ADDENDUM NO. 002

RE: Bristol Community Health Center, Phase I Renovations
For Southwest Virginia Community Health Systems
T&L Project No. 16493

DATE: April 4, 2023

Sheet No. **A201**

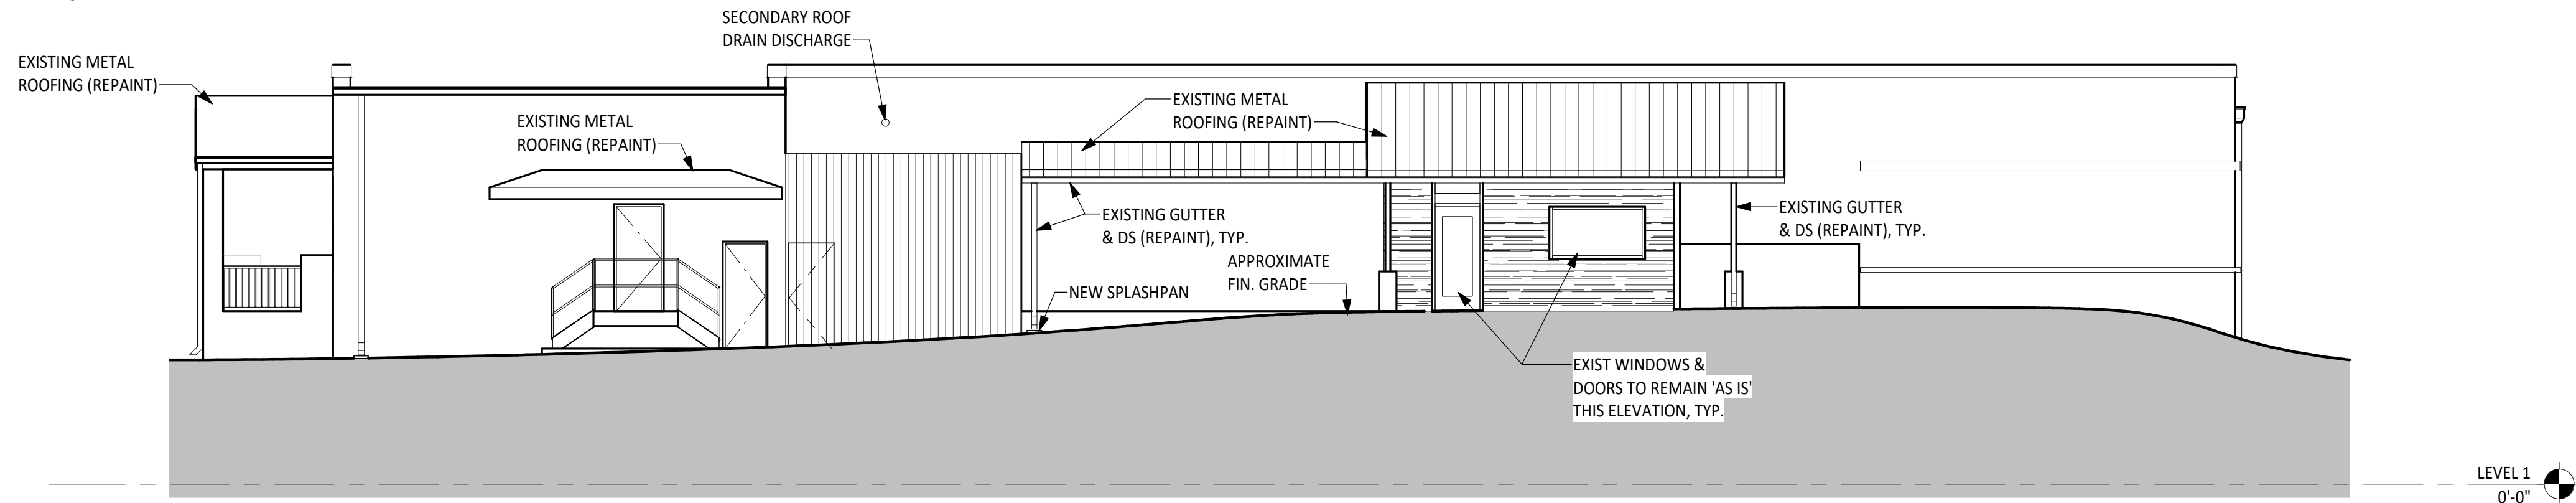
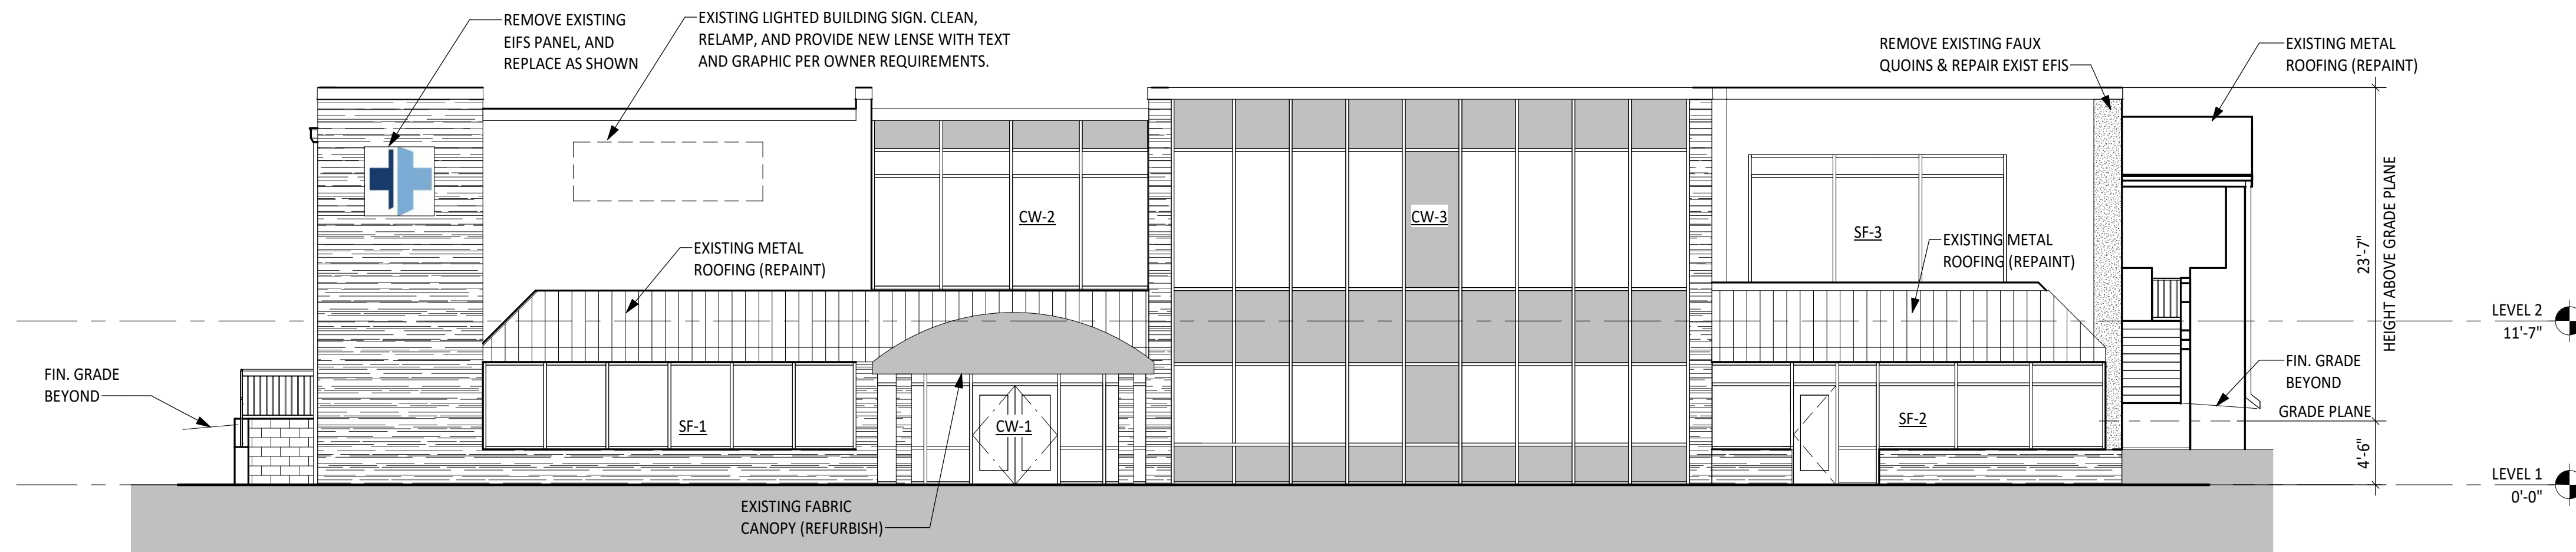
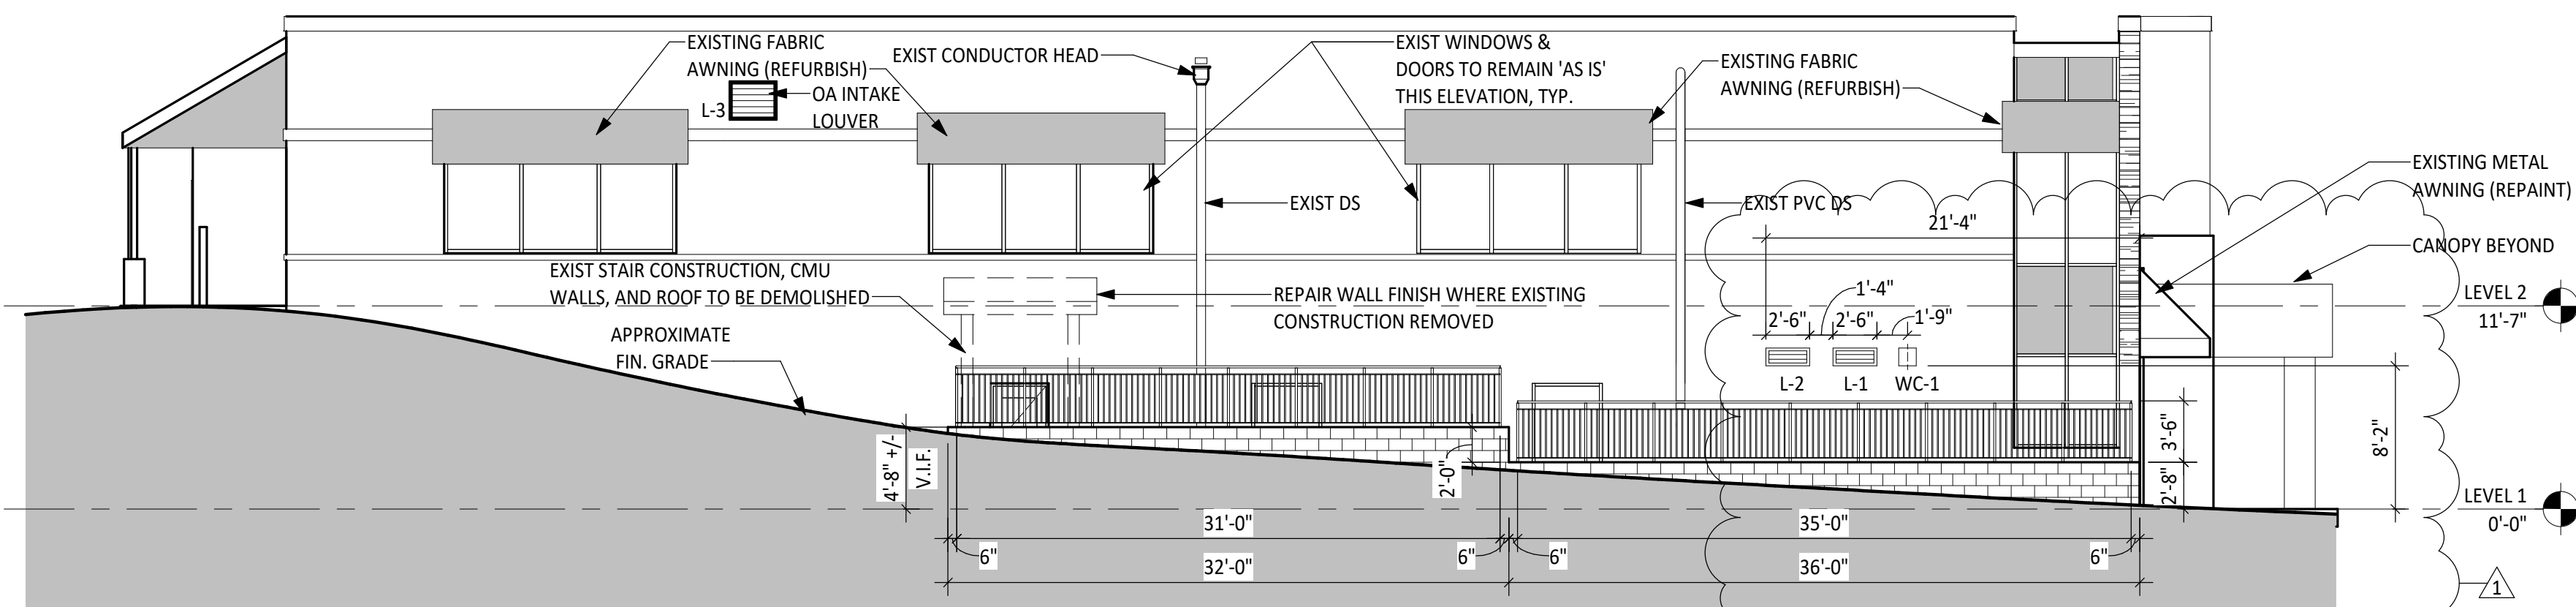
4. Refer to Drawing A103 for revisions to reflected ceiling at relocated elevator Machine Room 161 and Vestibule 162.
5. Refer to Drawing A601 for revisions and clarifications at elevator and machine room.
6. Refer to Drawing A201 for revised number and spacing of Aluminum Storefront Elevation (SF-4) and locations of wall cap WC-1, and louvers L-1 & L-2.
7. Refer to Drawing A701. Add new note no. 9 to General Partition Notes that reads, "Provide new 2-1/2" metal Z-furring at Partition Type A0.
8. Refer to Drawing A713 for revised Aluminum Storefront Elevation (SF-4).
9. Refer to Drawing S001 for "Typical Detail – Slab Replacement @ Utility Trench" and "Typical Detail – New Window Opening Existing Exterior Wall".
10. Refer to Drawing S100 for revised elevator shaft plan revisions.
